**ADDENDUM 4
To the
SITE SPECIFIC WORK PLAN (SSWP)**

**BUSH RIVER STUDY AREA
RADIOACTIVE WASTE MANAGEMENT FACILITY
NON-TIME CRITICAL REMOVAL ACTION**

Edgewood Area, Aberdeen Proving Ground, MD
Contract No. W91ZLK-04-D-0014
Delivery Order 0005

March 2005

**Figure 1. Route from Rad Yard to Outfall Discharge Point
Aberdeen Proving Ground**

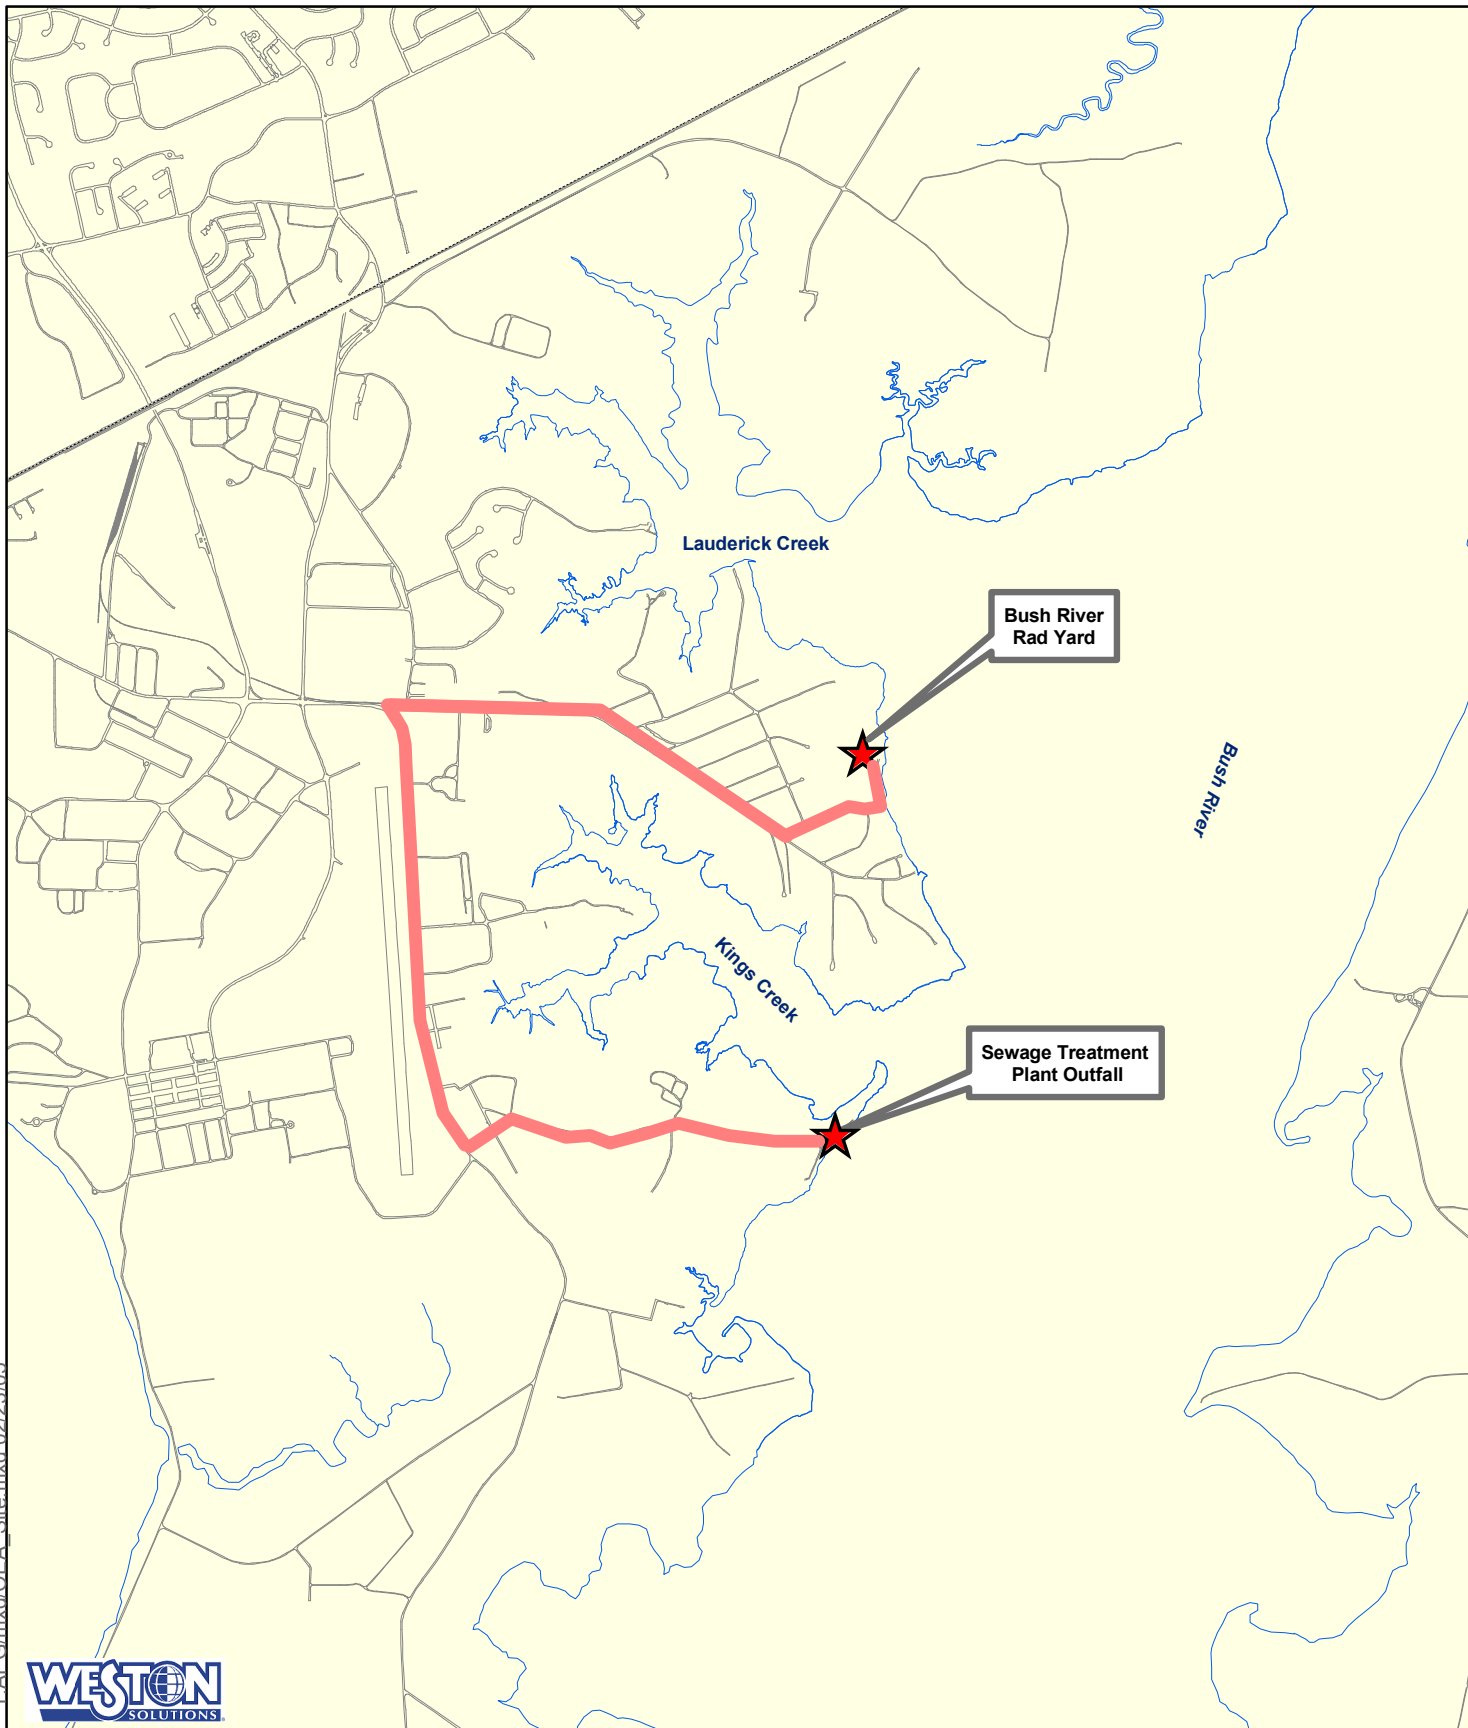
WESTON consulted with DSHE regarding the most feasible outfall to use for water discharge. A decision was made to use the existing permitted outfall for the Edgewood Area Sewage Treatment Plant located at the east end of Beach Point Road. Figure 1 provides a map of the area indicating the location of the Rad Yard site, the outfall location, and the route between the two. The NPDES Permit Number for this outfall is MD0021229 and the State Discharge Permit Number is 02-DP-2531. The treatment plant discharges approximately one million gallons per day of treated water to the Bush River via the outfall. This will allow the sump water discharge to mix with the pre-existing outfall discharge, diluting the levels of zinc, lead, and cadmium, as well as allowing the water to leave APG via a permitted outfall. MDE was consulted regarding the sump water results from each of these sumps. Per agreement with MDE, the expected maximum diluted concentrations of the metals were calculated and the following results provide adequate justification that the action levels will be met.

Figure 2. Sump Pit Water Discharge Flow Diagram

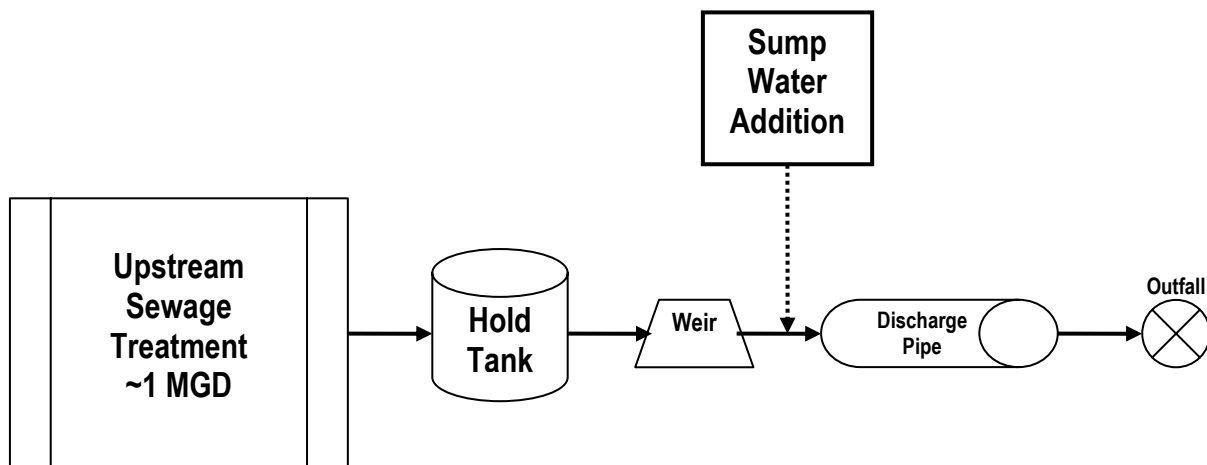
The truck will transport the water from the Bush River Rad Yard to the Sewage Treatment Plant discharge point and released into the outfall stream. There will be no access to the actual outfall since it is located in a restricted area. Therefore, the discharge point for the sump water will be just after the weir and just before the discharge pipe that leads to the outfall at the Bush River as indicated in Figure 2.

Figure 3. Bush River Rad Yard Sump Disposition Decision Tree

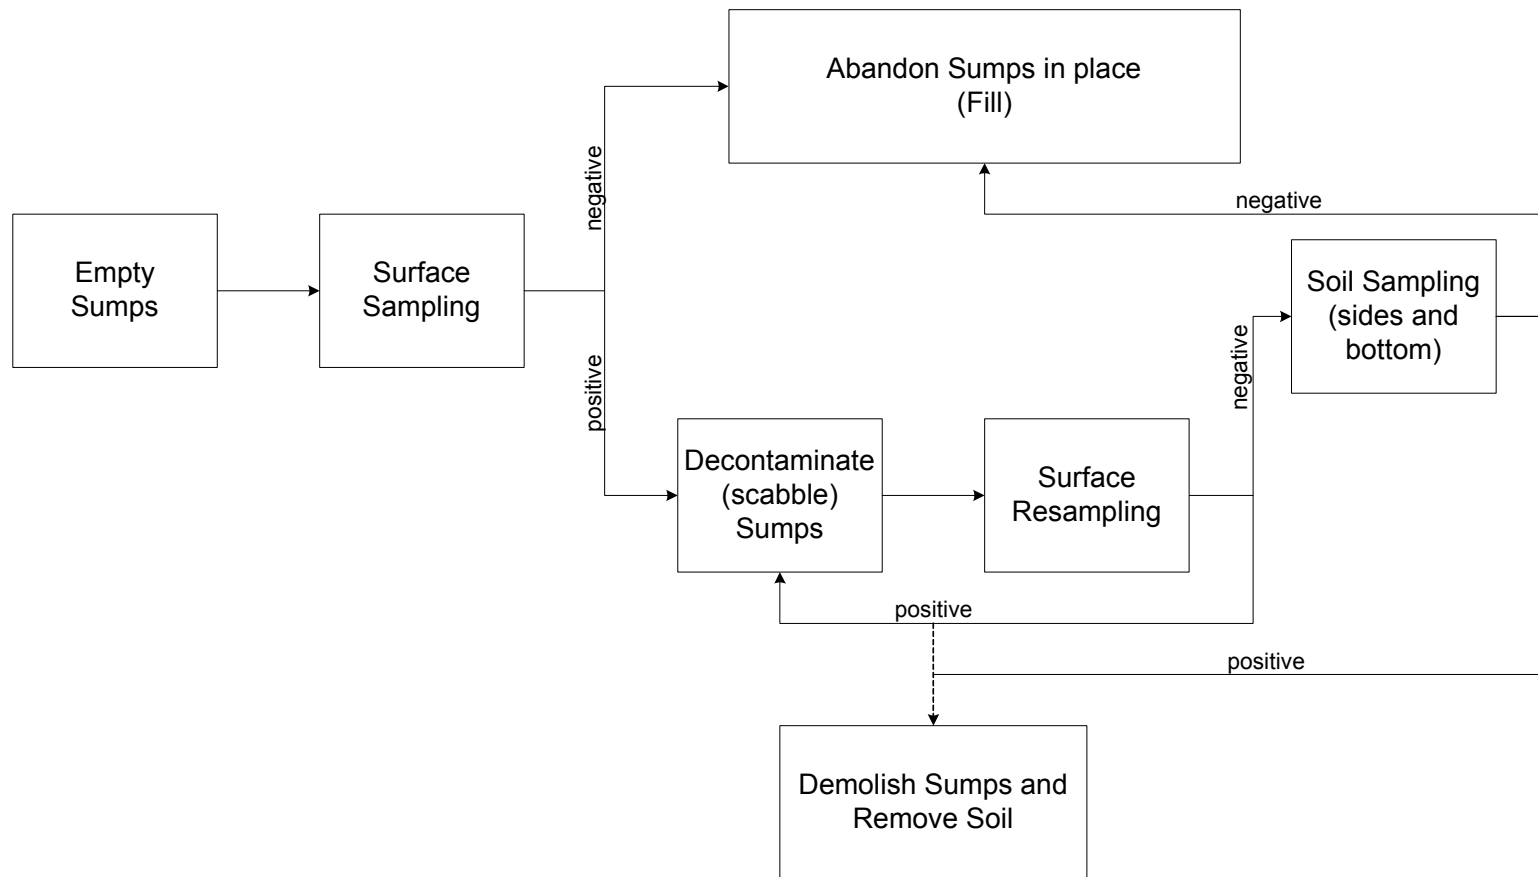
If either surface or subsurface sample results exceed the surface soil criteria of 5.5 pCi/g Cs-137 or 0.5 pCi/g Co-60, the contaminated soil will be excavated, segregated, and handled as radioactive waste. If the contaminated soil is below the valve pit or Sump 1, and the walls and floors must be demolished to access the contaminated soil, the concrete debris will be handled as radioactive waste. If the contaminated soil can be removed without demolishing the vessel, and upon confirmation through sampling and direct measurements that the criteria for surface soil was attained, the sump or valve pit will be collapsed in upon themselves and backfilled with soil or flowable fill, and abandoned in place.

Figure 3 provides a decision tree that depicts the process described above.
